Project	IEEE 802.16 Broadband Wireless Access Working Group < http://ieee802.org/16 >	
Title	802.16g_D6 GPCS_PROTOCOL_TYPE encoding Issues	
Date Submitted	2008-01-17	
Source(s)	David Johnston, NextWave Maximilian Riegel, Siemens	Voice: 503 629 0238 Fax: david.johnston@ieee.org
Re:	802.16g_D6	
Abstract	The GPCS_PROTOCOL_TYPE encoding in 802.16g_D6 is flawed since it inhibits upper layer protocol multiplexing and is incompatible with conventional 802 architectural models. This document explores the protocol layering cases that expose the problem and proposes a new definition that can satisfy both the purpose of the current encoding and the more flexible multiplexing model that IEEE Std. 802-2001 demands.	
Purpose	Consider and adopt the proposed changes to 802.16g_D6 as the resolution of David Johnston's sponsor ballot comment against 11.13.19.5.1	
Notice	This document has been prepared to assist IEEE 802.16. It is offered as a basis for discussion and is not binding on the contributing individual(s) or organization(s). The material in this document is subject to change in form and content after further study. The contributor(s) reserve(s) the right to add, amend or withdraw material

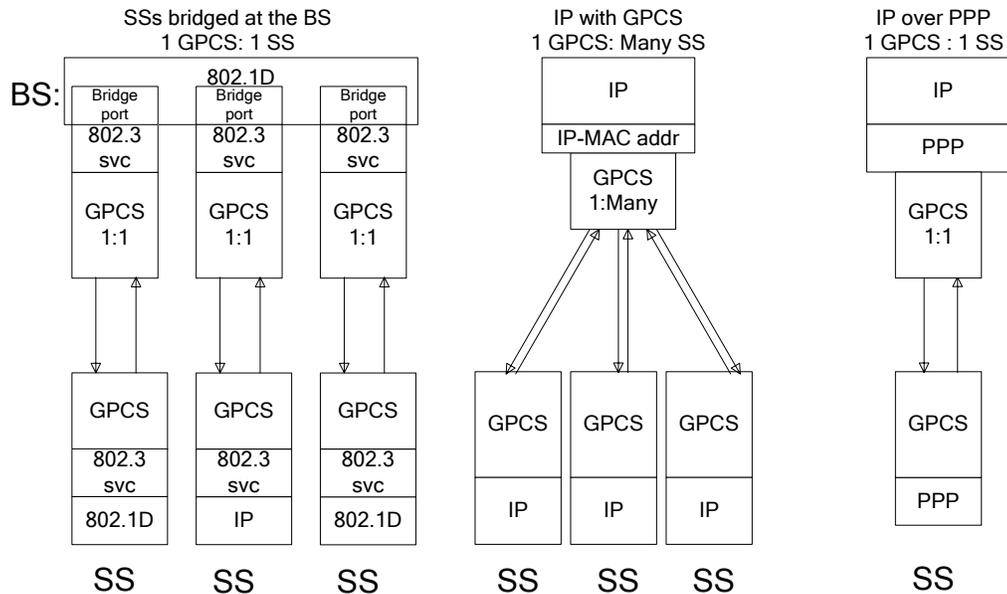
The relationship between GPCS instances and SSs needs to be clarified. To support GPCS-as-protocol-multiplexer style operation, 1 GPCS at the BS : many SSs should be allowed. To allow multiple point to point links with a bridge making the routing decisions, a 1:1 mapping should be allowed. It would be permitted for a BS to simultaneously provide a mix of such models, with SSs mapped to different GPCS instances either individually or in groups.

In the case of a GPCS instance at the BS peered with a single SS, the MS MAC Address primitive parameter on the GPCS_DATA primitive would be constant, set to the address of the peer MS.
